GRELOT ROAD SUBDIVISION, NORTHPORT HOLDING LLC, ADDITION TO

APPLICATION NUMBER 5 DATE March 9, 2017
APPLICANT Grelot Road Subdivision, Northport Holding LLC, Addition to
REQUEST Subdivision

DETAIL SITE PLAN

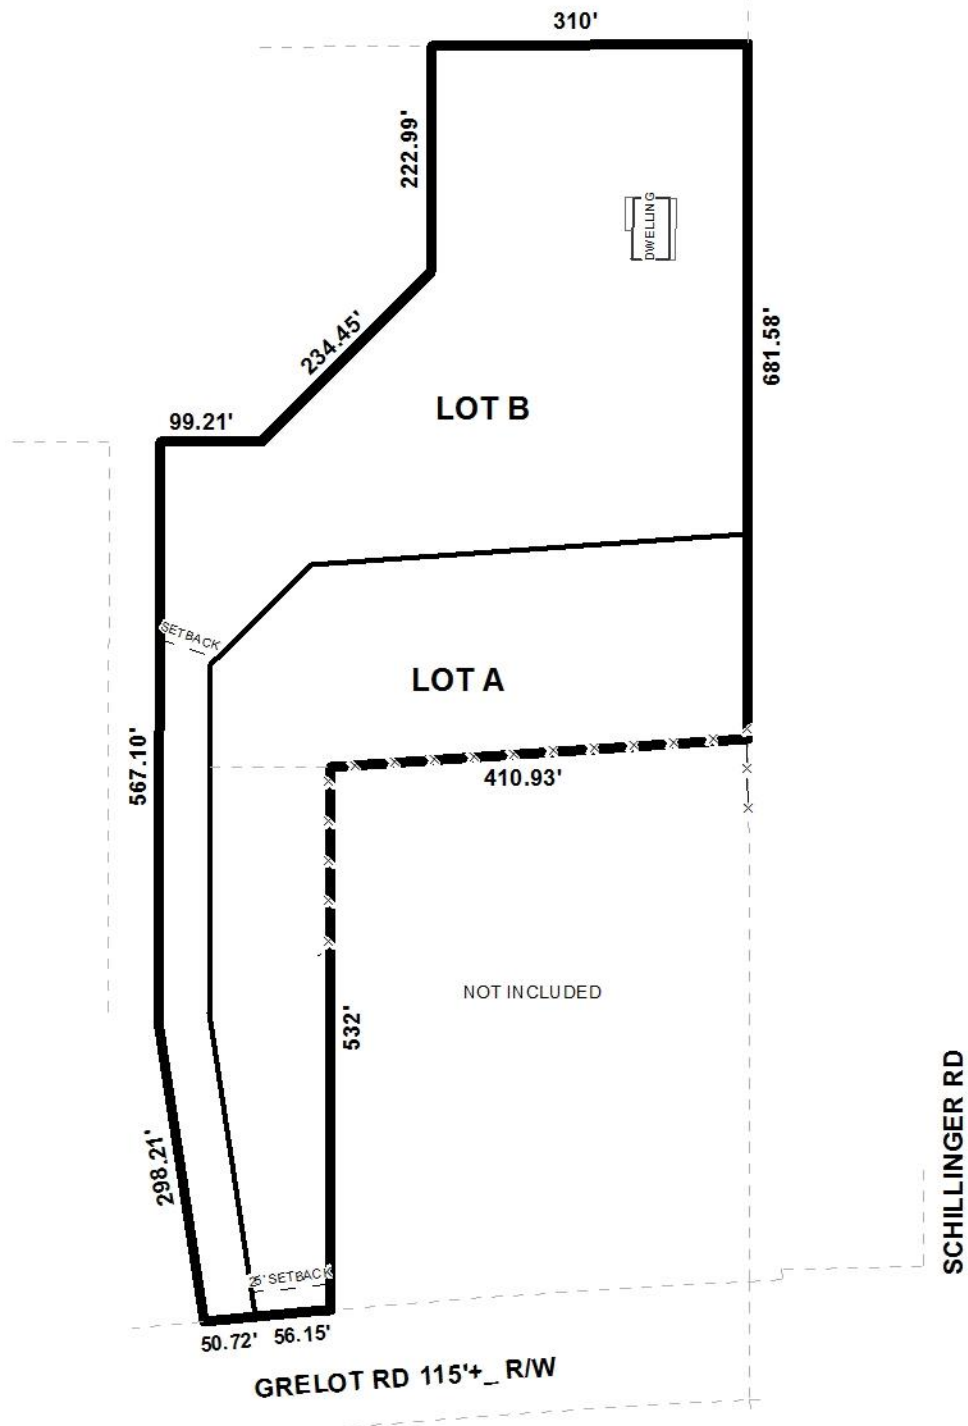
The proposed lots front Grelot Road, a major street with a 100' right-of-way as shown on the Major Street Plan Component of the Comprehensive Plan. The right-of-way width is depicted as "115'+'' on the preliminary plat and should be retained on the Final Plat, if approved.

The preliminary plat depicts minimum building setback lines for each lot. The setback line for Lot A is 25 feet from the property line. The setback line for Lot B is over 640' from the front property line, as that is where the proposed lot is at least 60 feet in width. If approved, the minimum building setback line for each proposed lot should be retained on the Final Plat.

The proposed lots appear to meet the minimum size and frontage requirements as stated in Section V.D.2. of the Subdivision Regulations, however, the proposed lots do not comply with Section V.D.3. of the Subdivision Regulations as it relates to the maximum width to depth ratio. Additionally, due to each lot's irregular shape, the proposed lots are also considered to be "flag" lots. Section V.D.1. of the Subdivision Regulations generally does not allow the use of "flag" lot configurations unless irregularly-shaped lots are common to the area, where there are natural or pre-existing man-made barriers which may cause an undue hardship to the owner, or in the case a family division. Being that this is a family subdivision and has previously been approved by the Planning Commission, a waiver of Section V.D.1. and Section V.D.3. of the Subdivision Regulations will be required, if approved.

The width of the "flag pole" sited along Grelot Road for the proposed Lot A depicts a distance of 74.92' wide, while Lot B has 50'± of frontage.

The proposed lots, ranging from 157,392 – 239,881 square feet, exceed the 7,200 square foot minimum lot size requirement for lots served by public water and sanitary sewer systems. The lot size information is depicted in both square feet and in acres on the preliminary plat, and, if approved, should be retained on the Final Plat.

As a means of access management, a note should be placed on the Final Plat, if approved, stating that Lots A and B are limited to one curb cut each to Grelot Road, with changes to the size, design and location of the curb-cut to be approved by Mobile County Engineering and conform to AASHTO standards.

With a waiver of Sections V.D.1. and V.D.3. of the Subdivision Regulations, this application is recommended for Tentative Approval, subject to the following conditions:

- 1) Retention of the right-of-way width along Grelot Road;
- 2) Retention of the 25-foot minimum building setback line along Grelot Road for Lot A;
- 3) Retention of the minimum building setback line along Grelot Road for Lot B where the lot is at least 60 feet in width;
- 4) Placement of a note on the Final Plat stating that no future subdivisions of Lots A and B is allowed, with the exception of interior lot line adjustments, until adequate frontage on a compliant public road or private street is provided;
- 5) Retention of the lot size information in both square feet and in acres for each lot;

- 6) Placement of a note on the Final Plat stating that Lots A and B are limited to one curb cut each to Grelot Road, with changes to the size, design and location of the curb-cut to be approved by Mobile County Engineering and conform to AASHTO standards;

- 7) Placement of a note stating that any lots which are developed commercially and adjoin residentially developed property must provide a buffer in compliance with Section V.A.8. of the Subdivision Regulations;
